PUBLIC WORKS/HYDROLOGY 1 OF 2

GRADING AND DRAINAGE PLAN
LOT 1 BLOCK 2, LOS ALTOS ADDITION
ALBUQUERQUE, NM
MAY, 1998

PUBLIC WORKS/HYDROLOGY 2 OF 2

GRADING AND DRAINAGE PLAN
LOT 1 BLOCK 2, LOS ALTOS ADDITION
ALBUQUERQUE, NM
MAY, 1998

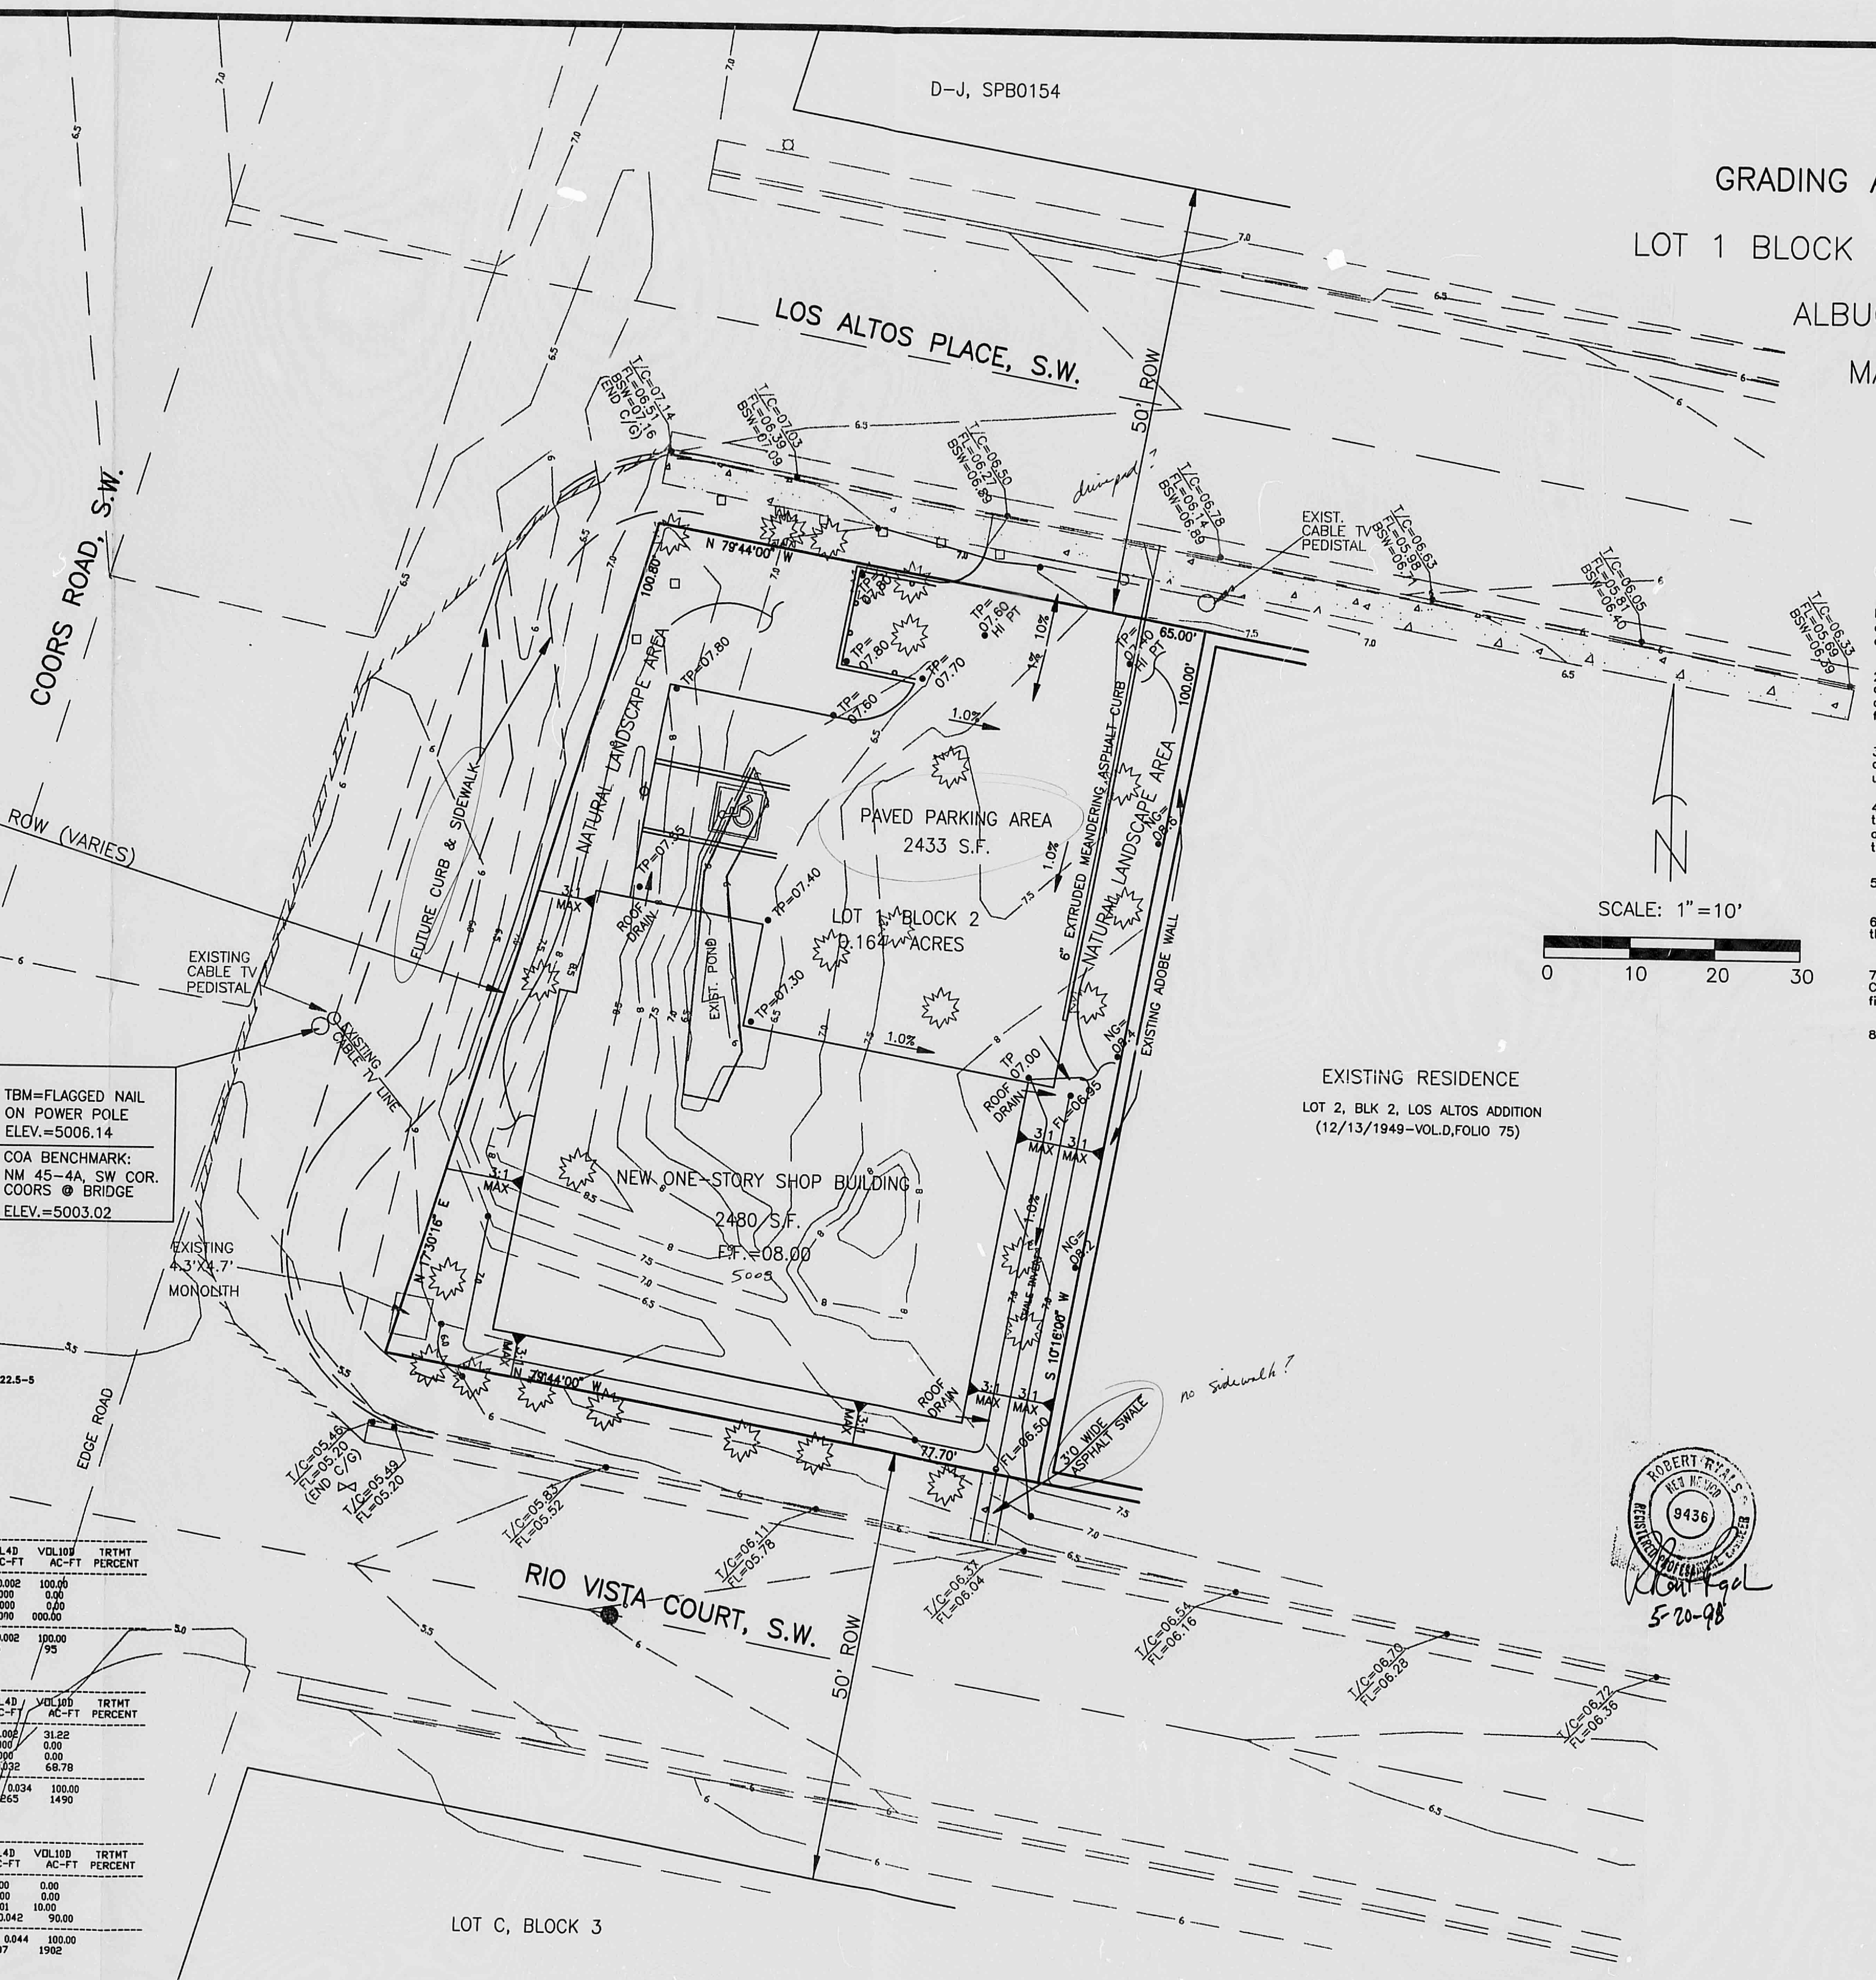
100.80'
65.00'
100.00'
77.70'
TP=07.80
TP=07.70
TP=07.60
TP=07.55
TP=07.40
TP=07.30
TP 07.00
TP=07.40 HI PT
TP=07.60 HI PT
NG=08.6
NG=08.4
NG=08.2
FL=06.95
1.0%
3:1 MAX
T/C=07.14 FL=06.51 BSW=07.16 END C/G
T/C=07.03 FL=06.39 BSW=07.09
T/C=06.50 FL=06.27 BSW=06.88
T/C=06.78 FL=06.14 BSW=06.89
T/C=05.90
T/C=06.33 FL=05.69 BSW=06.39
T/C=05.46 END C/G
T/C=05.63 FL=05.20
T/C=05.83 FL=05.52
T/C=06.11 FL=05.78
T/C=06.77 FL=06.34
T/C=06.54 FL=06.16
T/C=06.70 FL=06.28
T/C=06.72 FL=06.36
RIO VISTA COURT, S.W.
LOT C, BLOCK 3
EXISTING RESIDENCE
LOT 2, BLK 2, LOS ALTOS ADDITION (12/13/1949-VOL.D,FOLIO 75)
SCALE: 1"=10'
0 10 20 30
N
driveway?
no sidewalk?
floodplain?

landscape not "A"

outfall?
interim plan?
